PUBLIC UTILITIES COMMISSION

SA2026-1431

SUBJECT: Electric Substation Audit of PacifiCorp Yreka Headquarters

CPUC SUBSTATION AUDIT FINDINGS

RECORD OF RELAY OPERATIONS

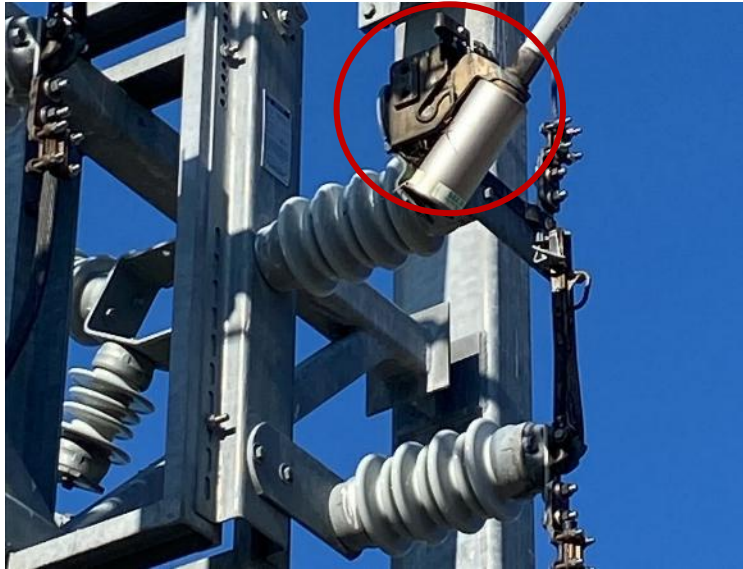
7.7. Circuit Breaker 5G19 has an incorrect entry on the relay operations card. The counter increased but the corresponding fault operations did not increase on November 27, 2024.

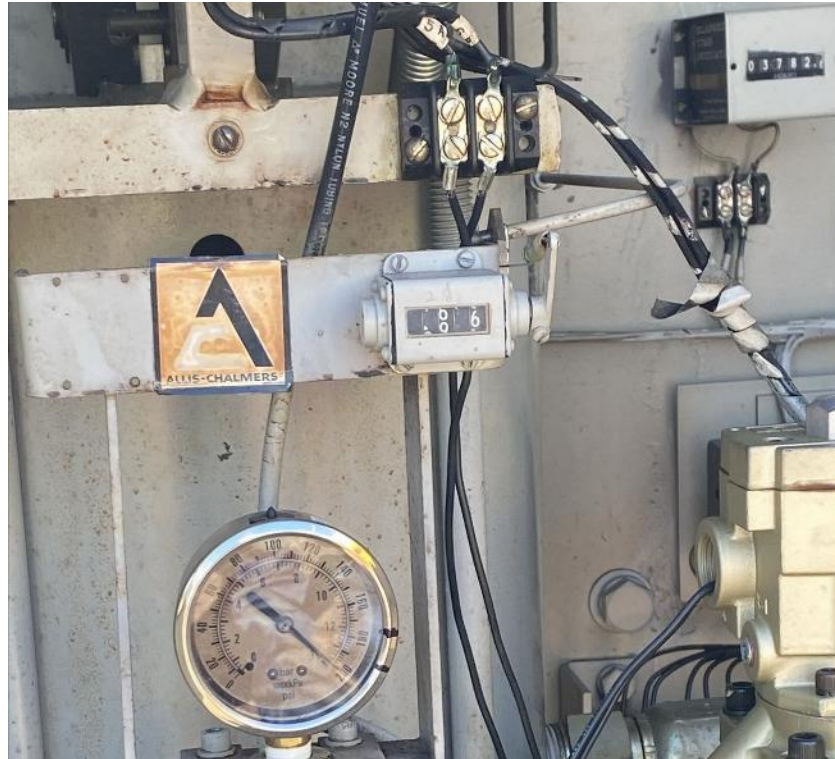
8.6. Switch 2G120 has a faded counter.

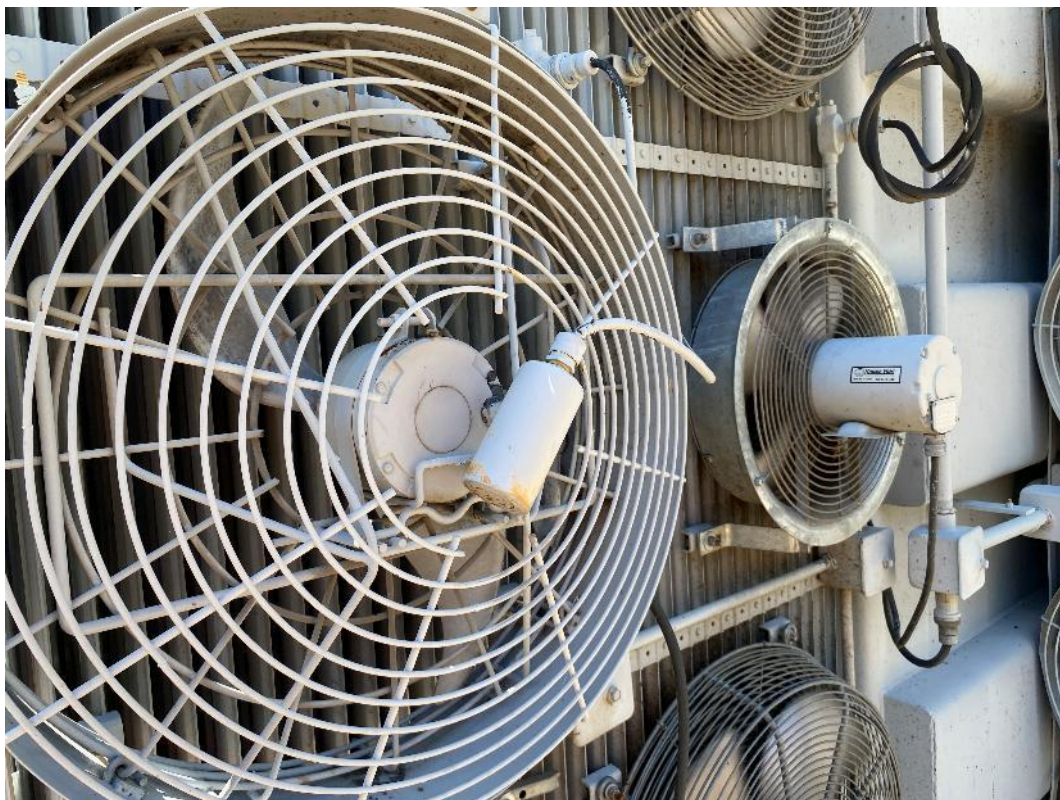
10.5. Switch 3G602 has a faded label.

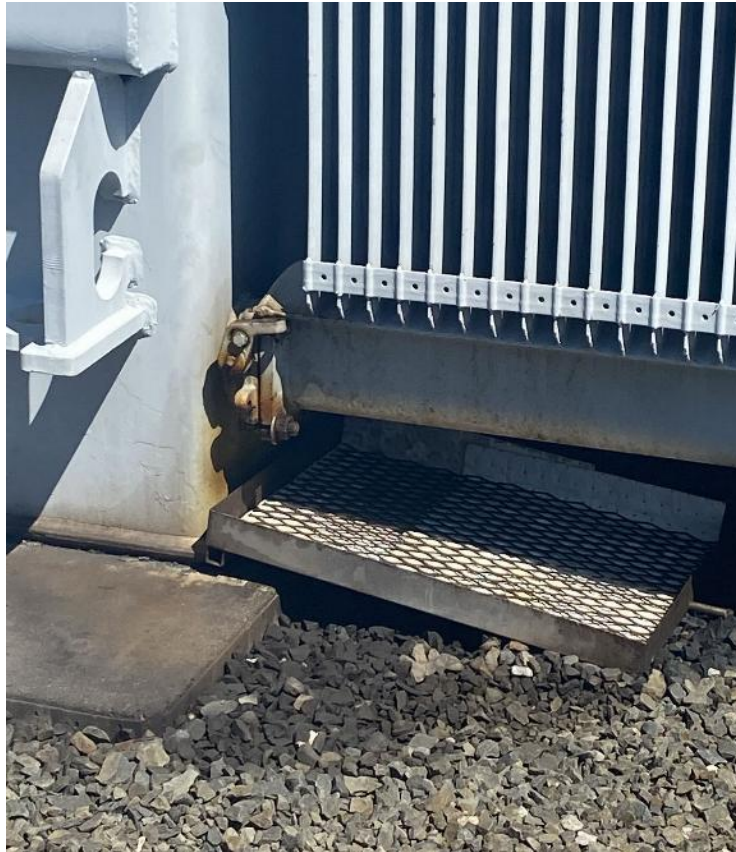
10.8. Transformer Bank 2 has a broken fan.

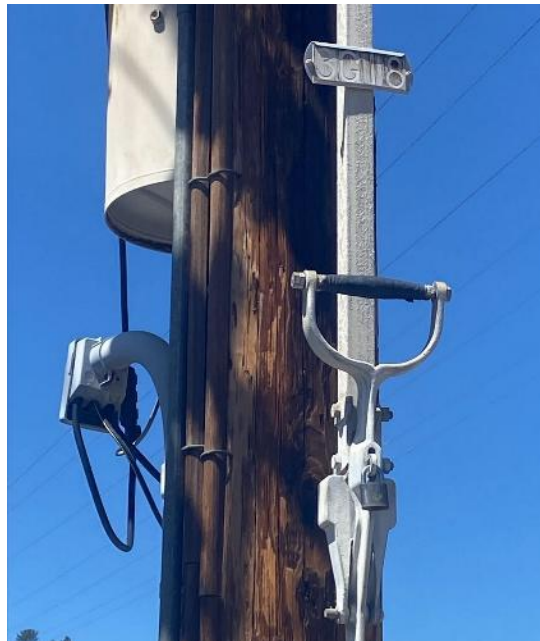
15.3. Regulator 1276 motor gear box has an oil leak.
